1. Whistlebait Estates Addition No. 2; KPB File 2024-100
Vector Surveying LLC Magnitude & Direction / Rubbert, Whistlebait LLC
Location: Valley View Road, Desmidt Avenue & Jacobsen Avenue
Sterling Area

ITEM #1 - PRELIMINARY PLAT WHISTLEBAIT ESTATES NO 2

STAFF REPORT

Aerial with 5-foot Contours

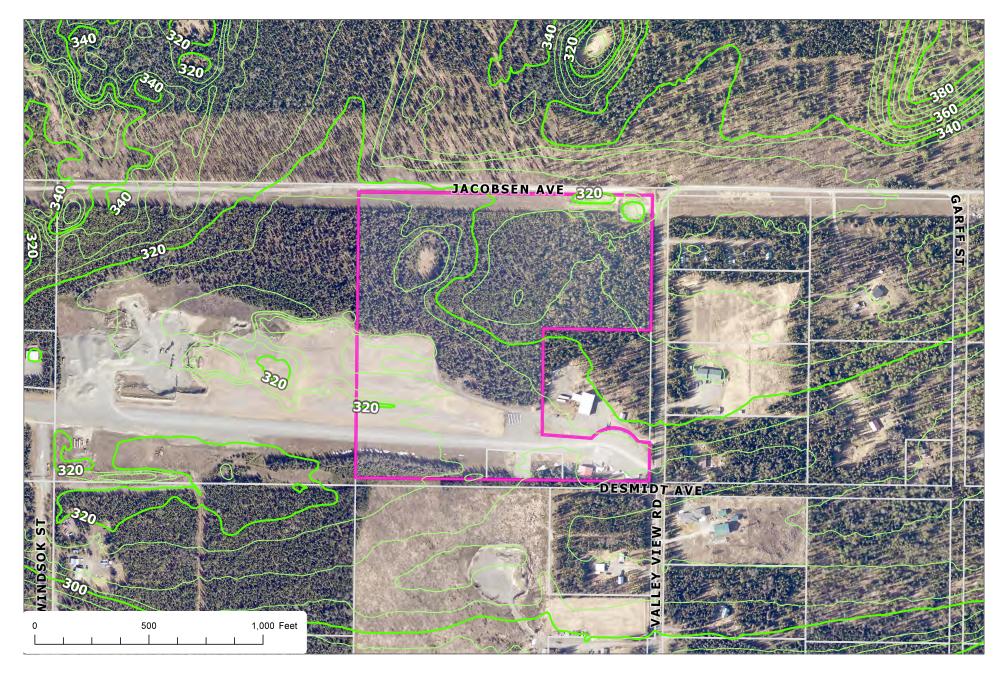
The surveyor did supply a supplemental drawing with contours on it. Steep areas were not identified on it though. Staff reviewed KPB GIS contour data and determined there are areas with slopes over 20% that should be shown on the plat. Staff recommends the steep areas be added to the final submittal.

IN 3 SHEETS SHEET NO.1

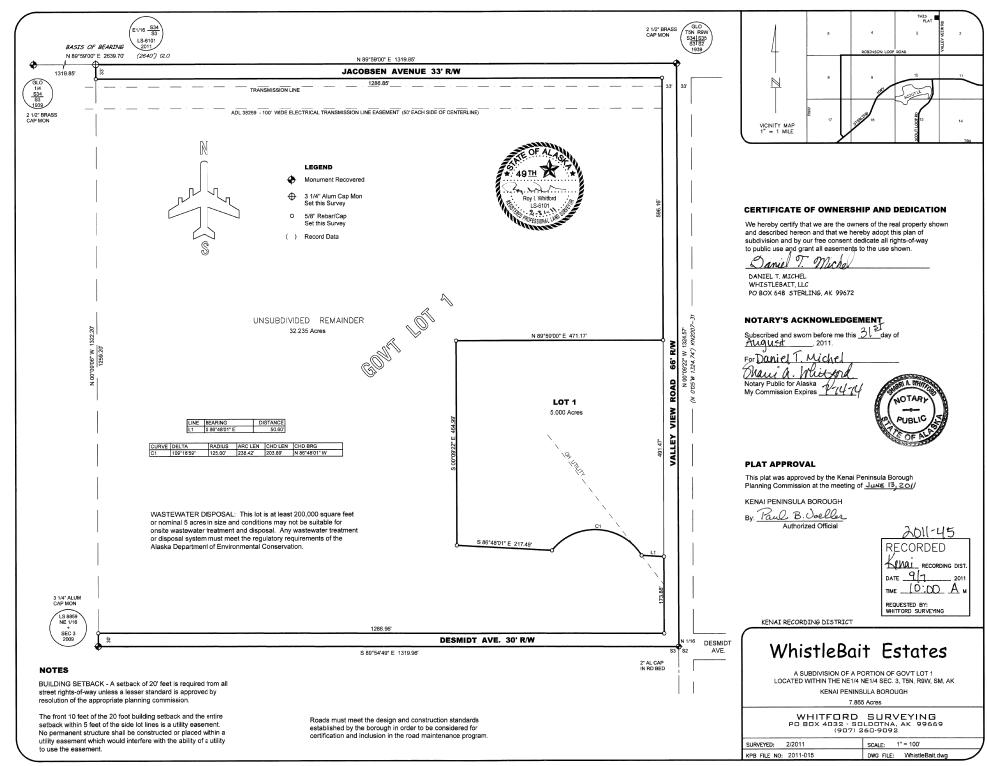
Add the date of October 28, 2024 to the Plat Approval

Darken the outer boundary of the plat to match the line indicated in the legend

Change reference to plat note 11 in structure near southeast corner of plat to note 12.

Plat notes #9 & #12 appear to be similar in context and should be combined.

Plat note #7 can be removed as no new road is being dedicated.

Revise legal description to represent the parent plat in the first paragraph rather than the legal description of the parent plat.

Need to change scale of drawing 1:70 is not within plat specifications per KPB 20.60.070.

Add the 33' section line easement along the north.

All 4 tracts to the east need the plat label corrected

Parcel to the southwest should be labeled with the plat waiver resolution and recording info

Parcel to the west can have the section down removed from the label

Lot 3 should be relabeled as Lot 3A

Label the adjusted lines as former lot lines.

Steep areas need shown on drawing and labeled

On the transmission line south of the building setback off of Jacobsen Ave, parent plat shows it as an Electrical Transmission Line, please correct.

Plat note #5, easement is described as being no more than 100' from the north line of Lot 1 of Section 3 within the document. Please add to the drawing.

Verify the location of the ADL near the north line. Whistlebait Estates KN 2011-45 shows the easement line to be approximately 100' from the north line of the ROW.
